Test results of Validation test 1b and Cycle modifications

Prepared by Japan

the 12th DHC group
under GRPE/WLTP informal group

29 March 2012

5. Proposed WLTC ver.5 for Validation 2

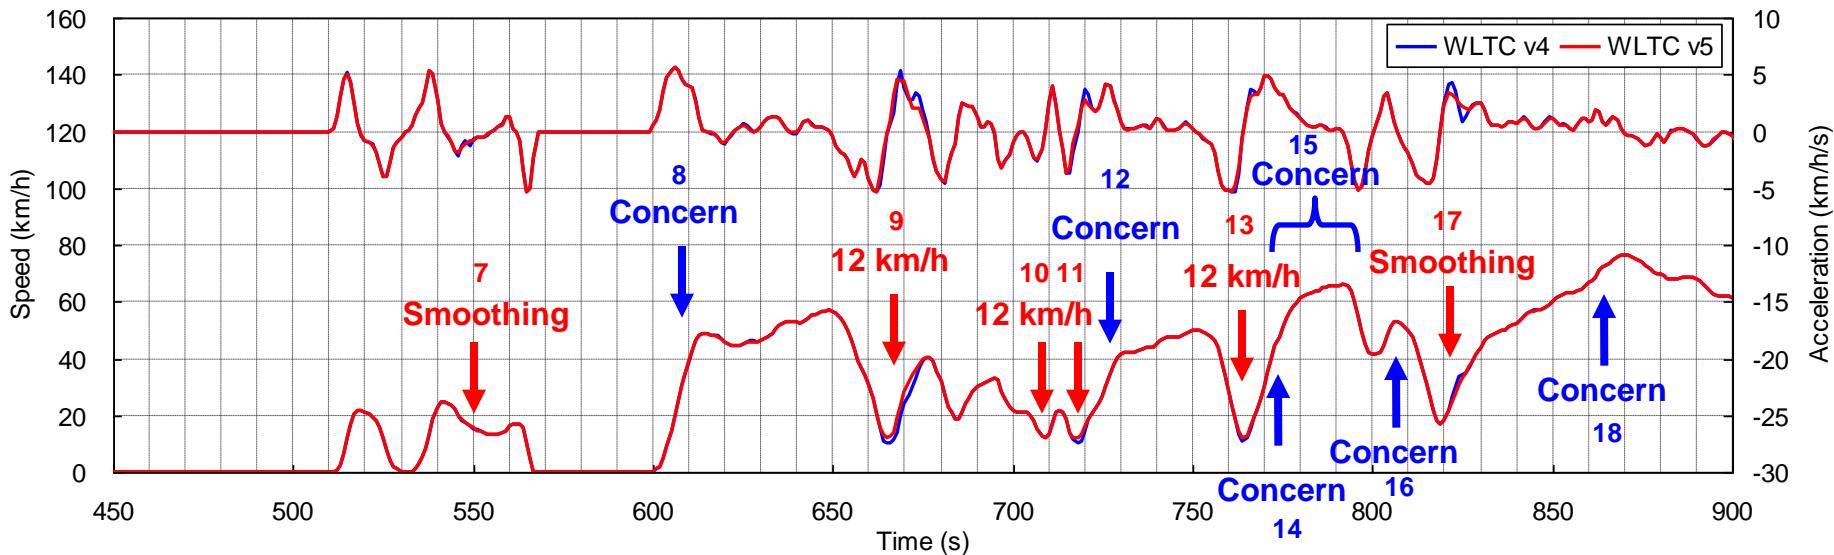
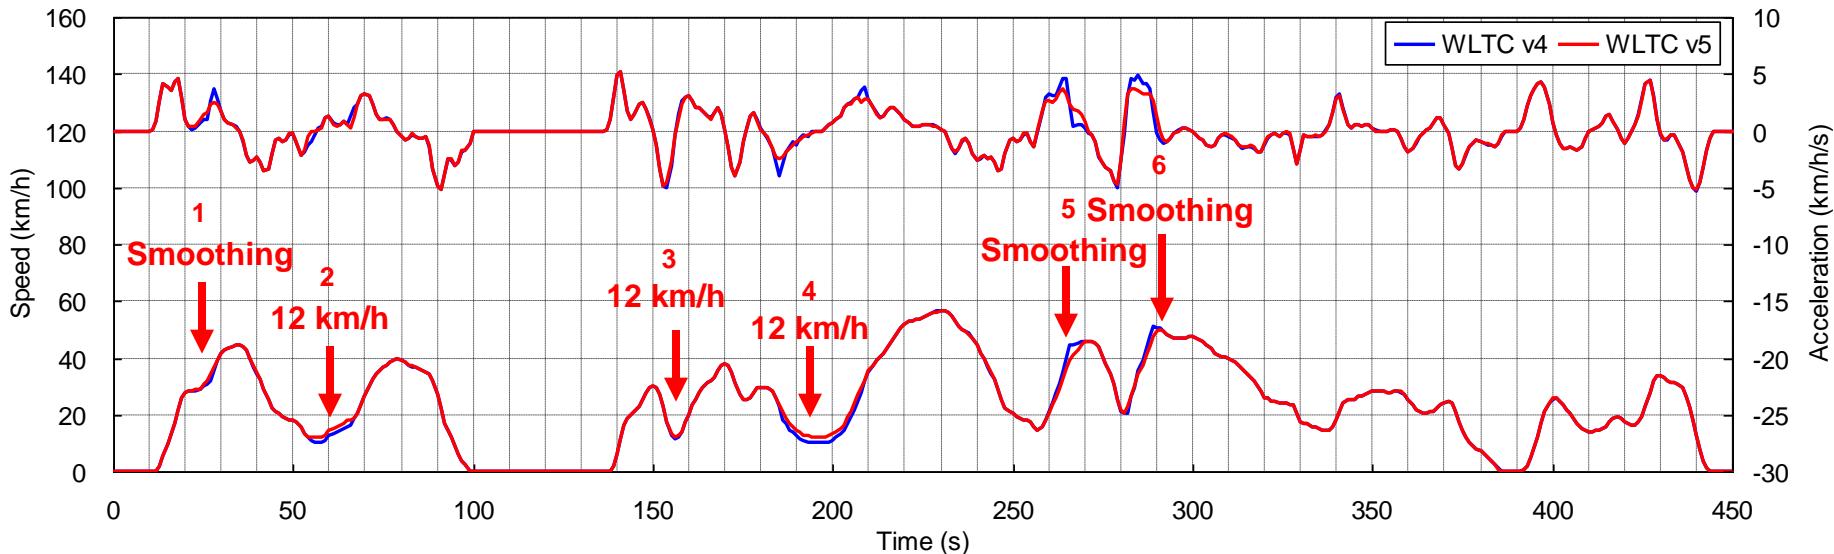
- As a first step to move forward to validation 2, Japan propose to modify the following items (15 portions).
 - the minimum speed set to 12km/h
 - Smoothing to improve repeatability
 - Set vehicle speed one decimal point
- Other 16 remaining portions regarding dynamic concerns which was indicated by India and Japan should be considered during Validation 2.

31: Time chart was changed from two decimal point to one decimal point
